ARMED FORCES RADIOBIOLOGY RESEARCH INSTITUTE

SUBJECT: Submission of Annual Report

1993  
Annual Report  
of the  
AFRRI TRIGA Reactor

Docket 50-170

**Bypass Switches Added to Damper Closure Circuit**

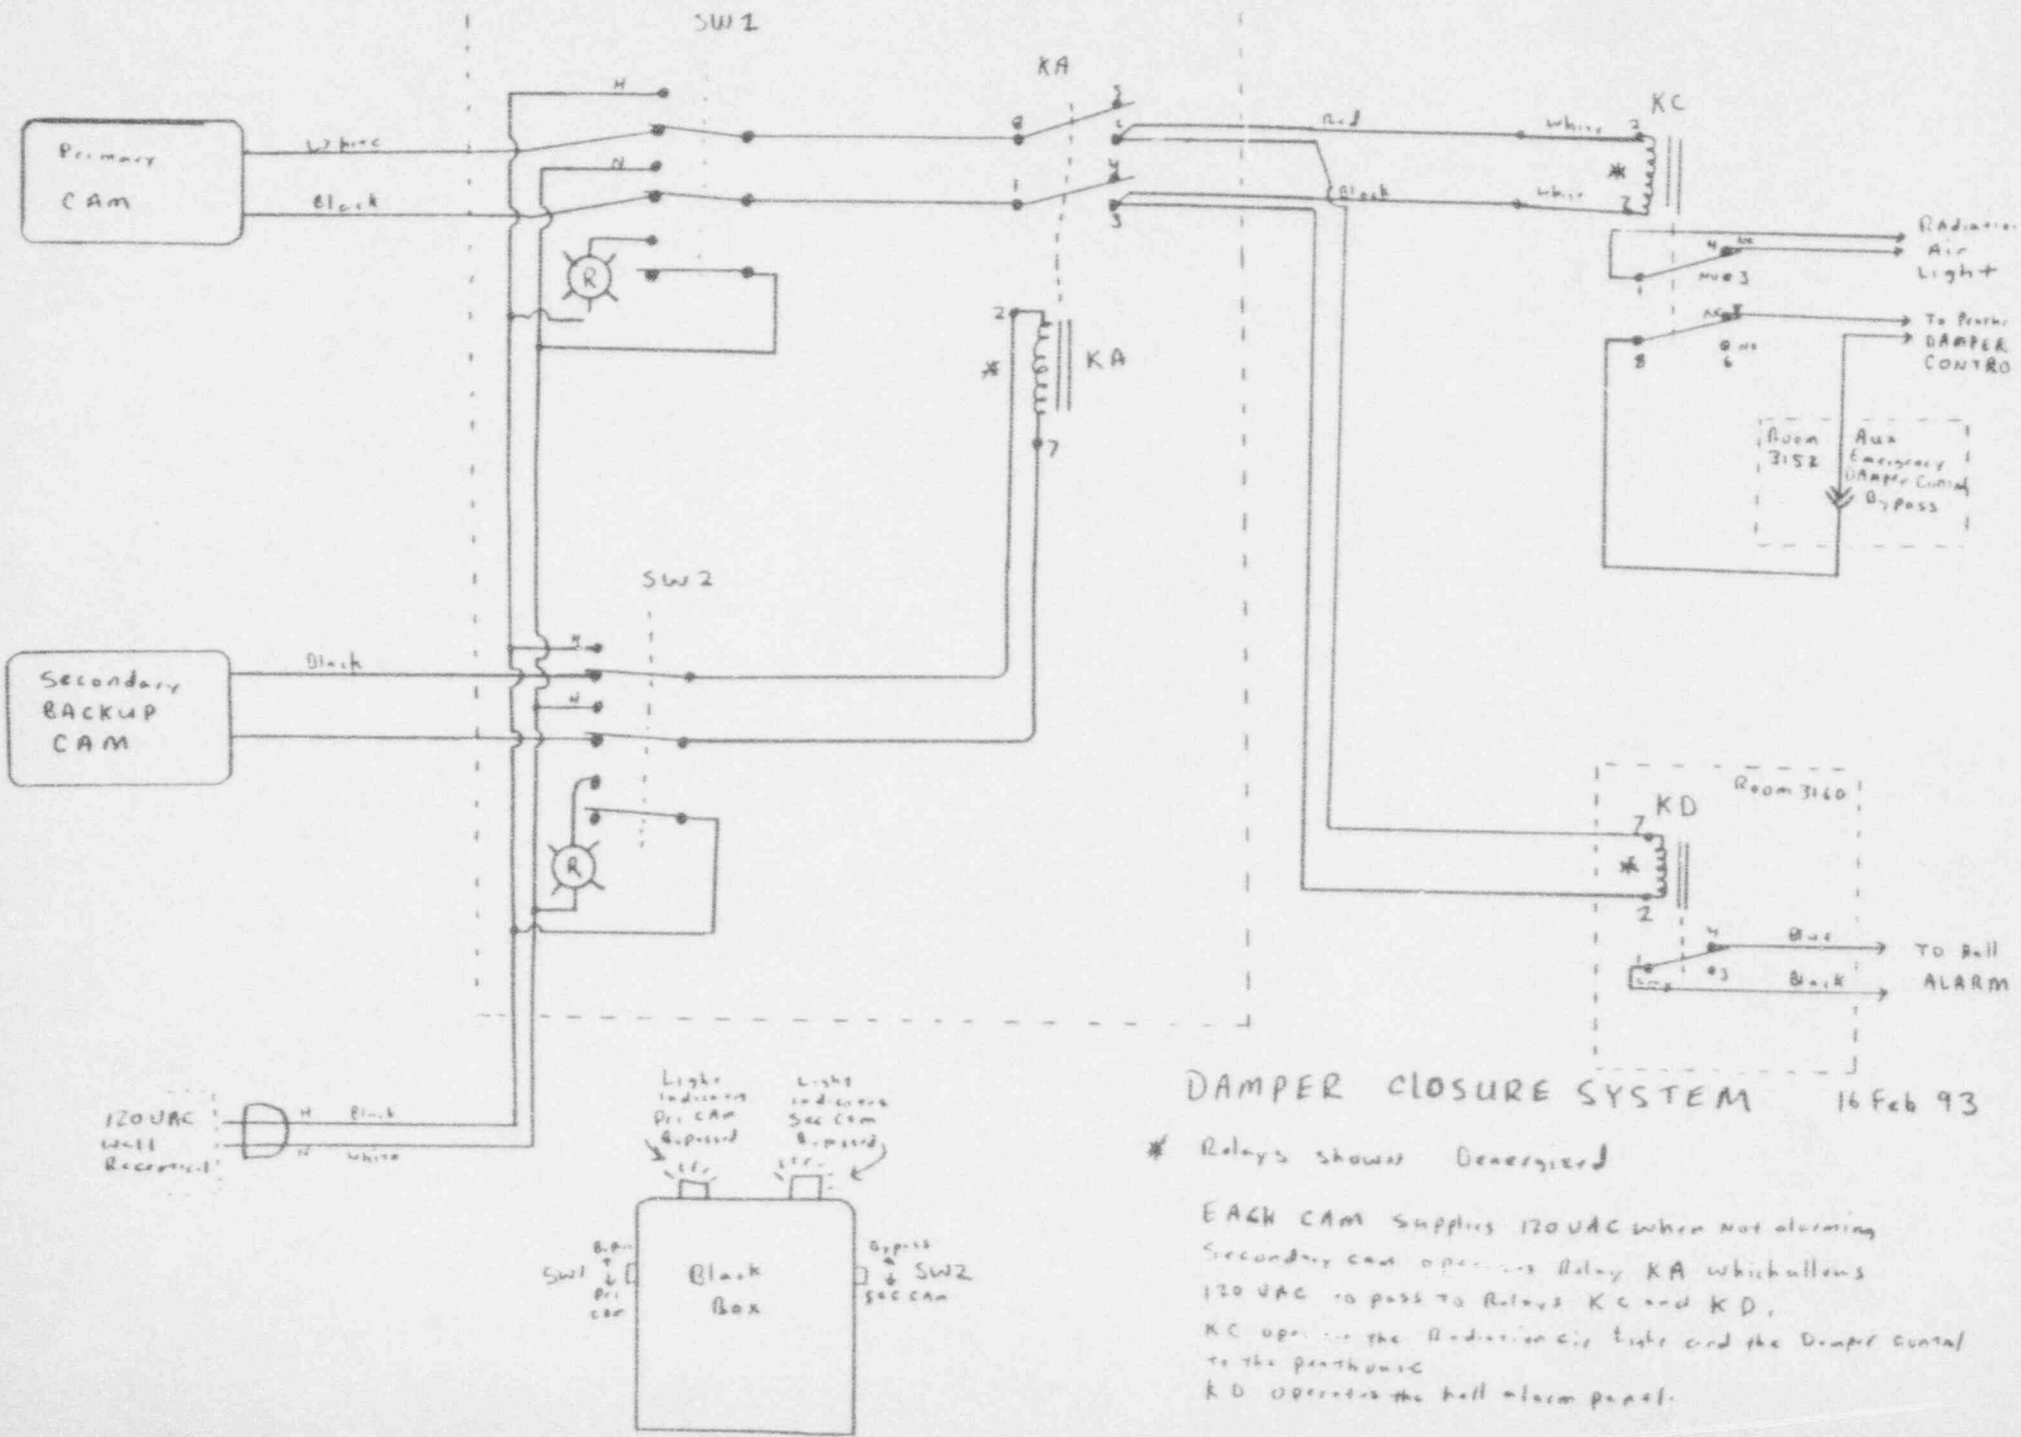
Switches Added will allow the dampers to be opened if either the primary or secondary cum fails. This will allow air flow during repair times into the Reactor Room. A light will indicate that a cum is bypassed.

5. List of associated drawings, procedures, logs, or other materials to be changed:  
Drawings Attached and old versions updated

## Water Box Gamma Monitor - Audible Alarm

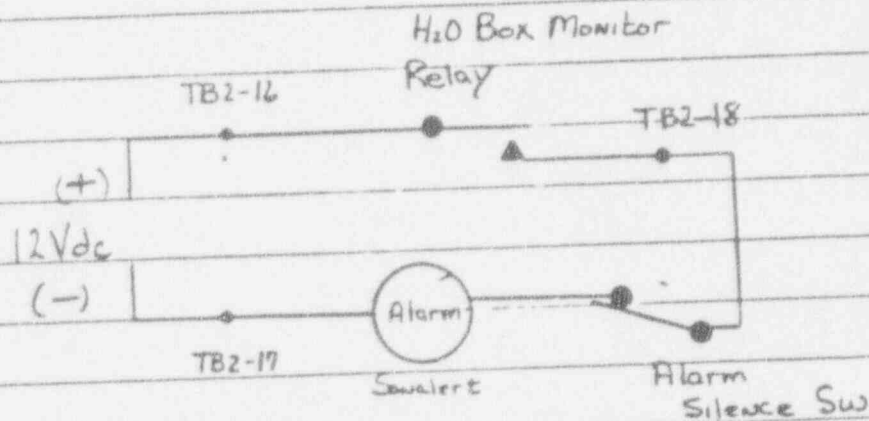
1. Description of change: a audible alarm (12Vdc Sonus 7) and the on alarm switch will be added to the water conductivity monitor. Alarm will use existing wiring in Hel box monitor. Circuit as follows.

Proposed Change Install a Air Sample Port in Reactor Room Wall

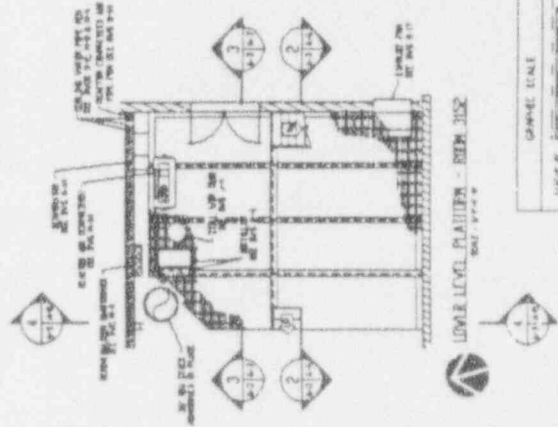
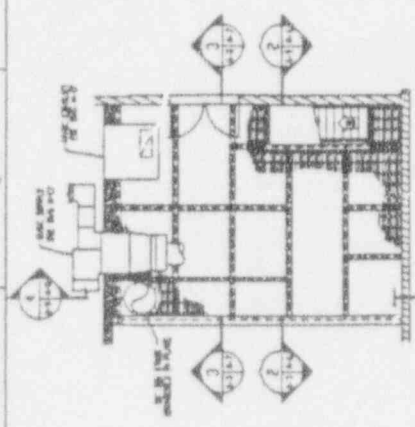
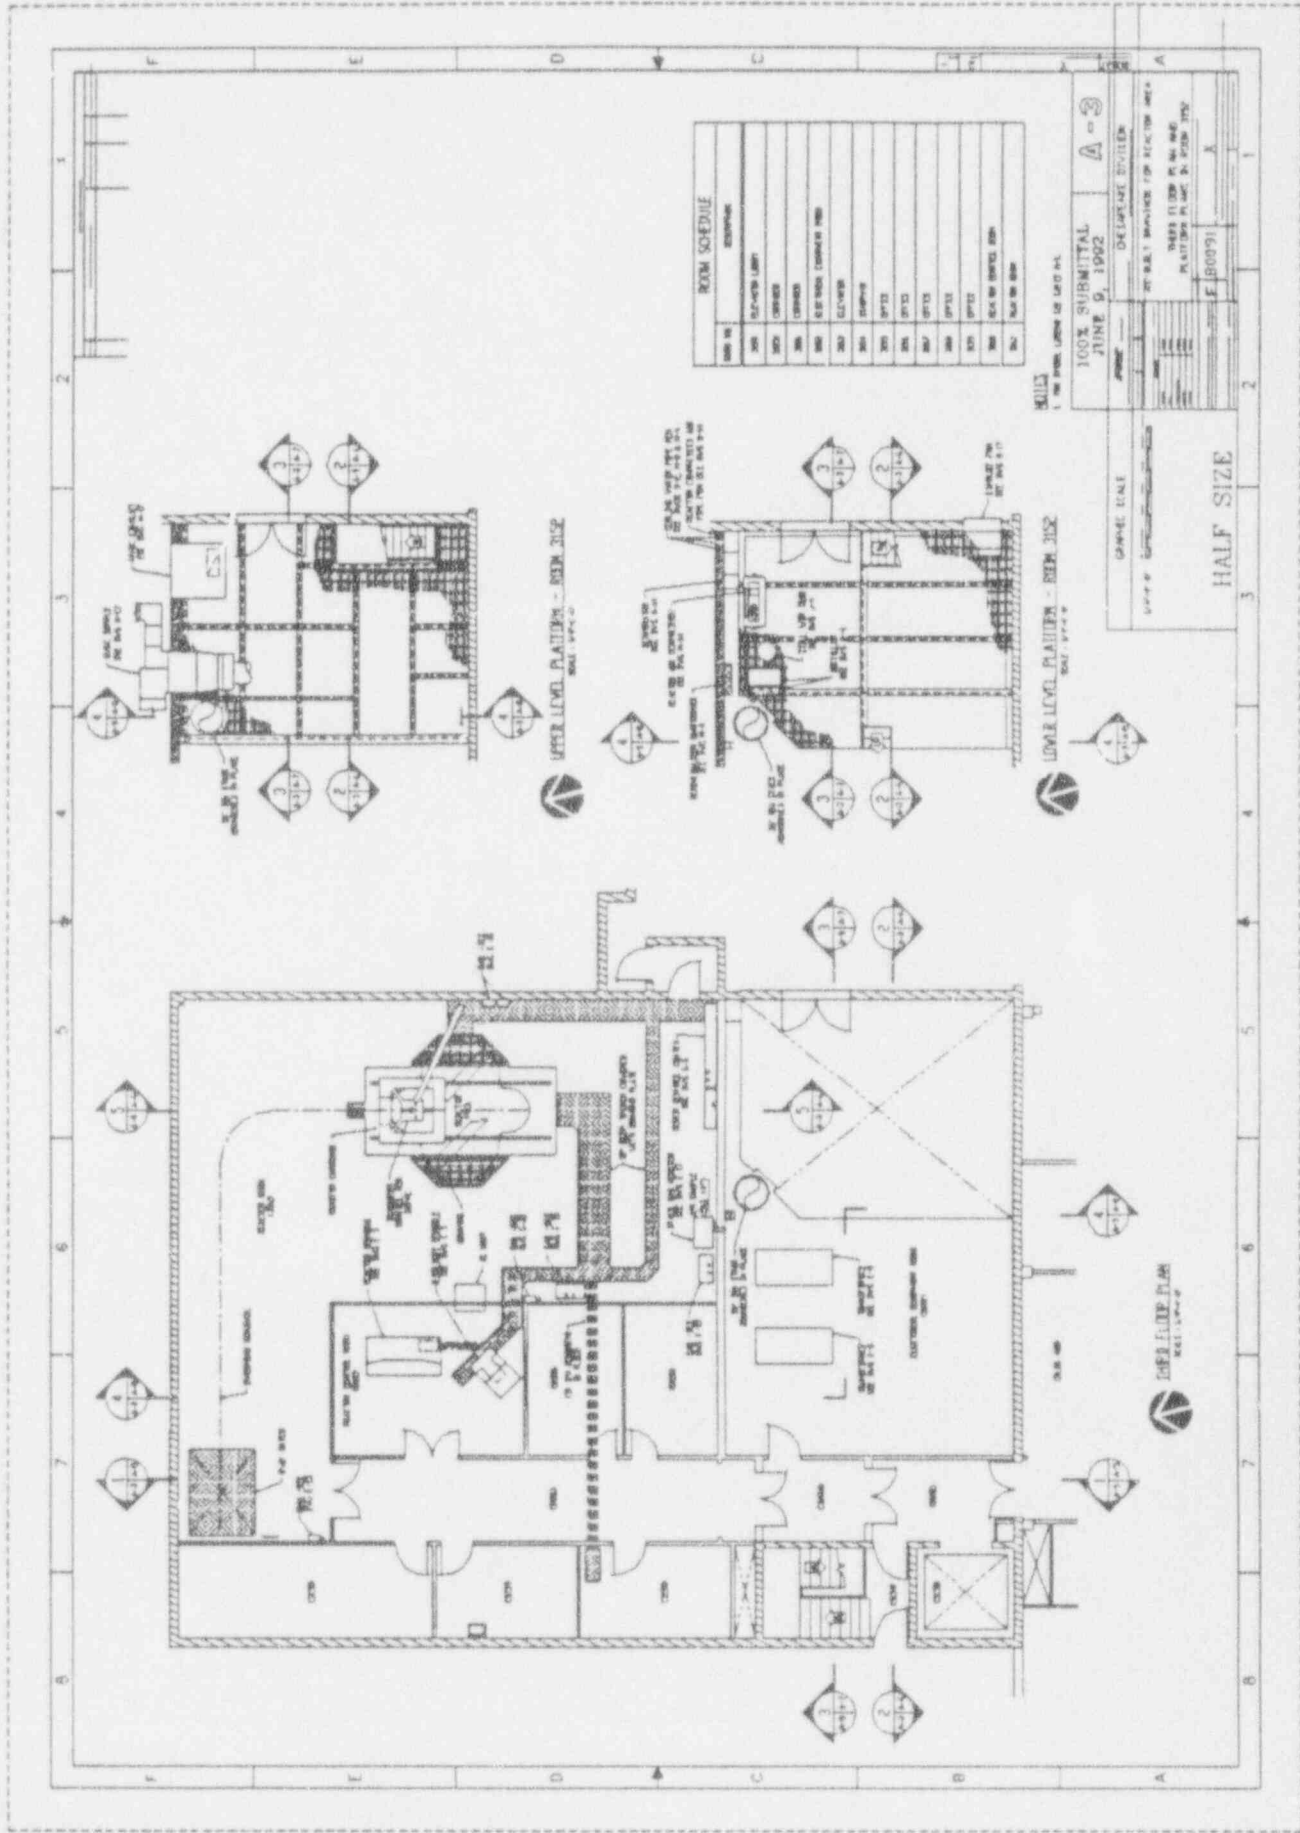
Drill/Cut a Hole In the wall Between the Reactor Room and the equipment room (3152), install a 1/2" or PVC pipe in the hole and seal the pipe in place. The pipe will be threaded on the Equipment Room side and a cap will be secured on to seal the opening. The Hole (4.5" ID pipe) will be used during emergencies to Sample Reactor Room air with a Simplex Air Sampler.
